MONTGOMERY COUNTY HISTORIC PRESERVATION COMMISSION
STAFF REPORT

Address:	3713 Underwood St., Chevy Chase	Meeting Date:	5/27/2020
Resource:	Clark House Individually Listed Master Plan Site	Report Date:	5/20/2020
Applicant:	Hannah Graae & Duke Schaeffer	Public Notice:	5/13/2020
Review:	HAWP	Tax Credit:	n/a
Case Number:	35/75-20A	Staff:	Dan Bruechert
Proposal:	Hardscape alterations, fence installation, Stair replacements

3713 Underwood Street – Deteriorated back porch stair

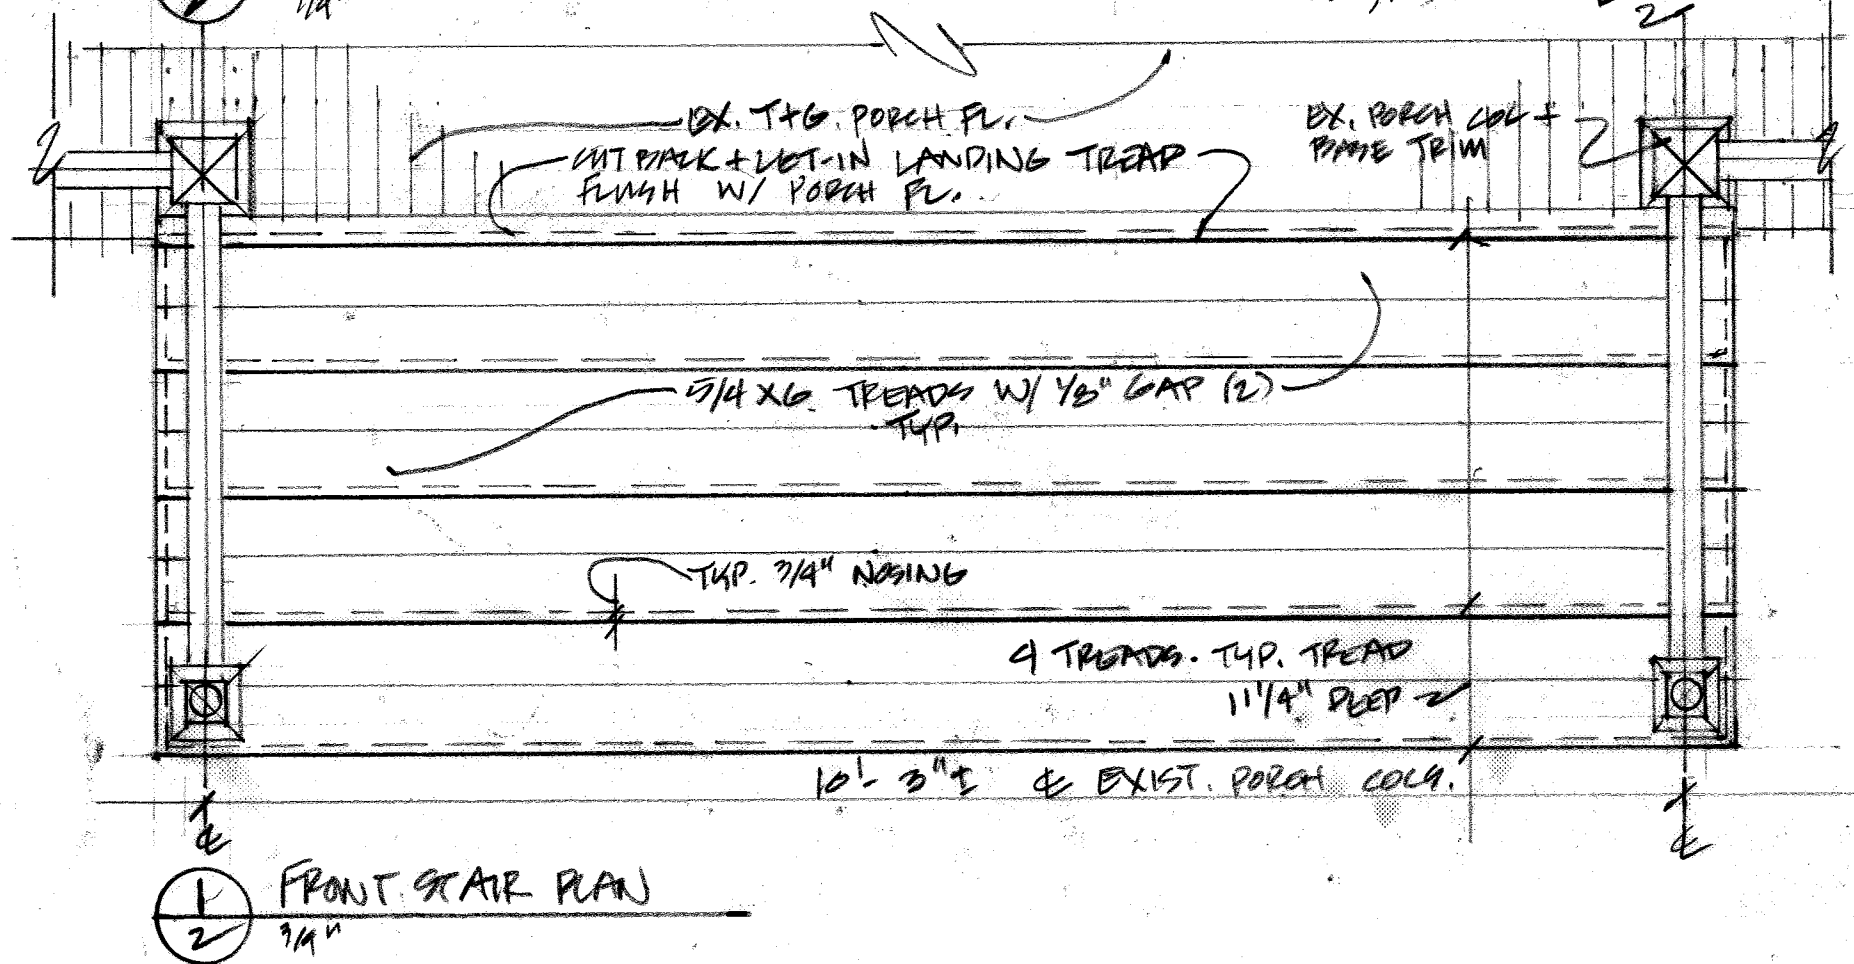
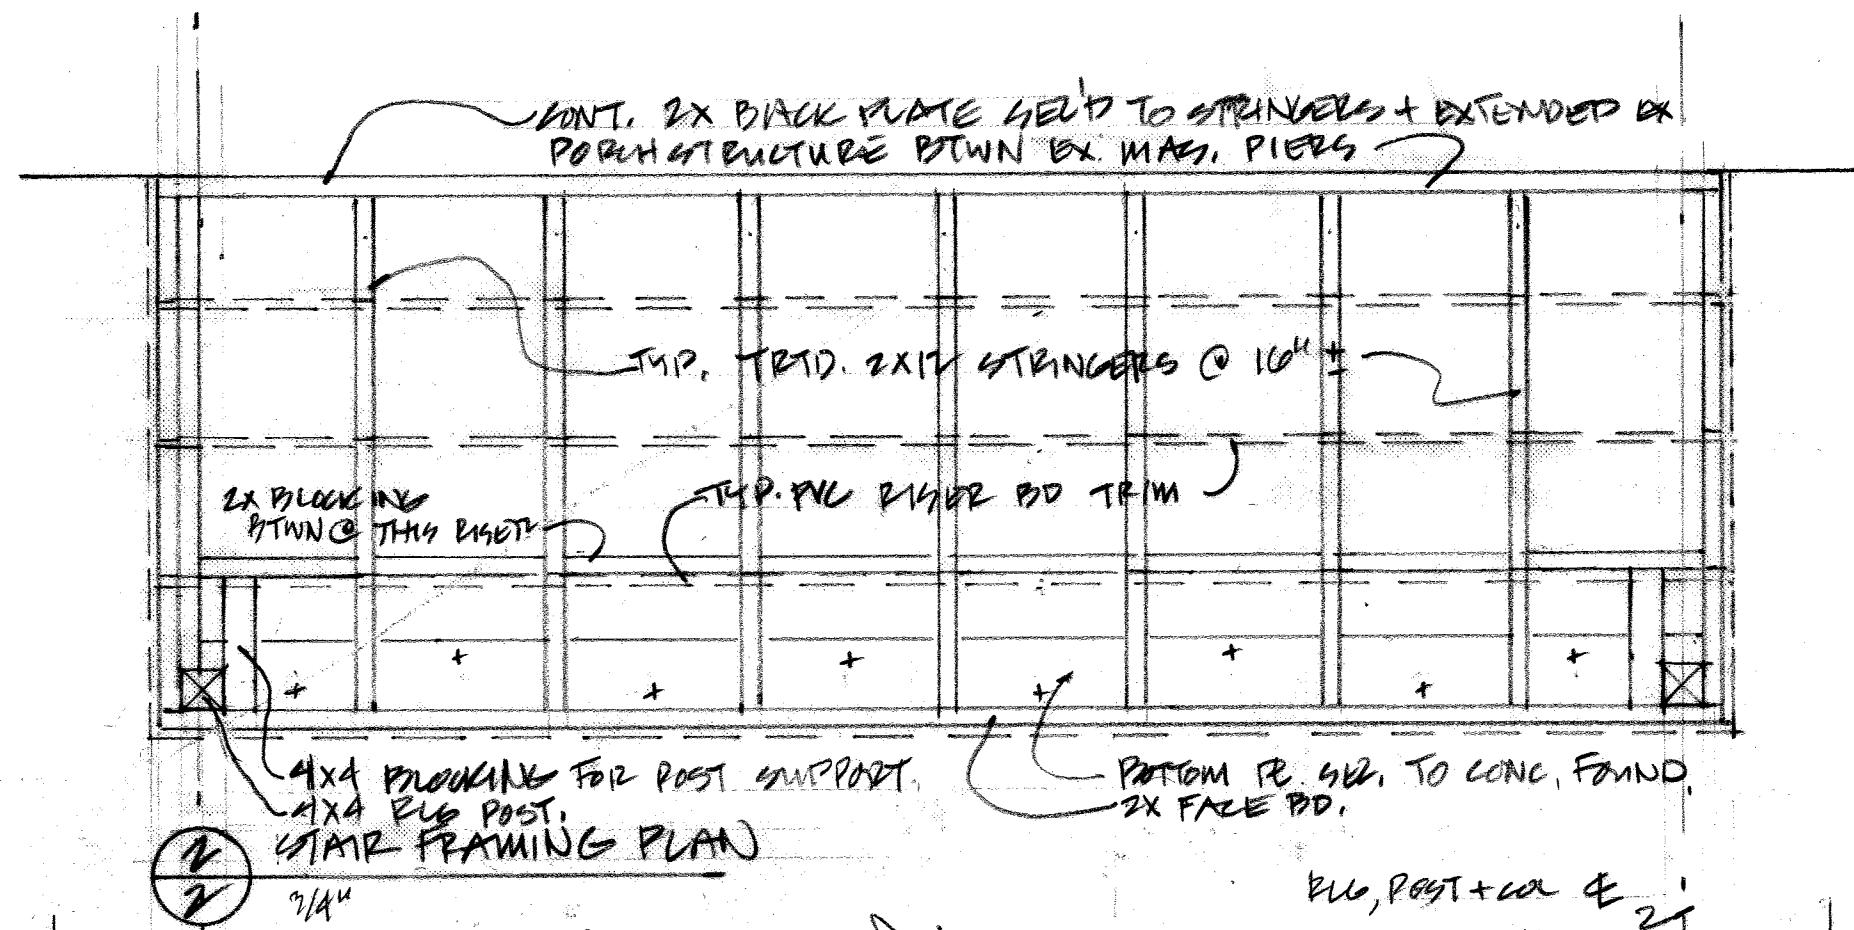
On the west (left) side of the house, there is a wooden staircase that provides exterior access to the rear screened-in porch. The applicant proposes to removing this set of stairs and to install a new side loading staircase on the east side of the porch. The proposed stairs will be wood with a wood handrail. Staff finds the existing stairs are not historically significant and their removal will not detract from the historic character or significance of the resource. Staff finds the proposed stairs are an appropriate material (wood) and are placed in a location that will not detract from the historic character of the house.
